Minutes of **68th PCC meeting**

MINUTES OF 68TH PROTECTION SUB-COMMITTEE MEETING HELD AT ERPC, KOLKATA ON 18.06.2018 (MONDAY) AT 10:30 HOURS

Figure: Loading of 400kV Talcher-Meramundali and Talcher-Angul on 16th may 2018

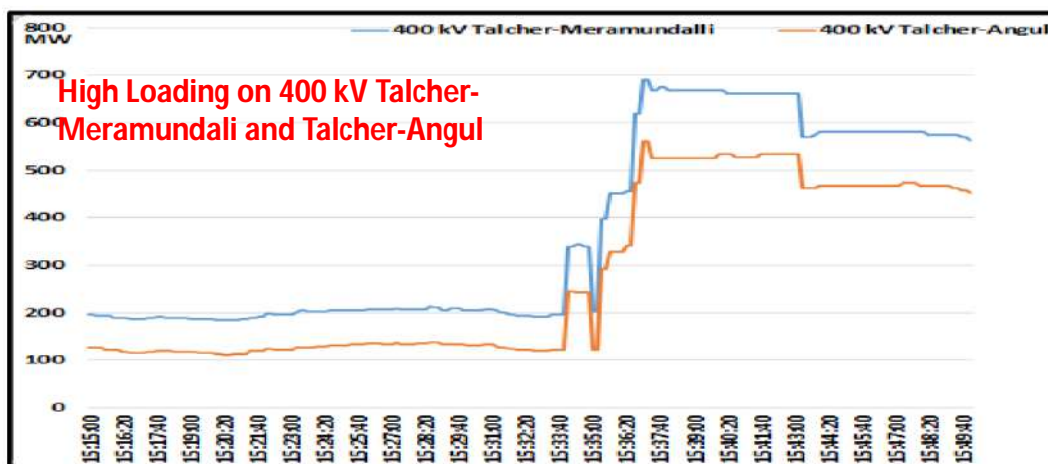
1. Severe loading on 400 kV Talcher-Meramundali and Talcher-Angul circuit (Refer Figure)
2. High loading on the 765/400 kV Vemagiri ICTs (Refer Figure).
3. Due to inadequate generation reduction at Talcher in eastern region the loading on 400 kV Talcher Stage 1 and 2 Interconnector were more than 1400 MW for 6 minutes (Refer Figure).

PCC may like to discuss the issue of inadequate backing down at Talcher causing overloading of network in Eastern region under such contingencies along with the issue of slow generation backing down at GMR and other issues at JITPL as quoted above.
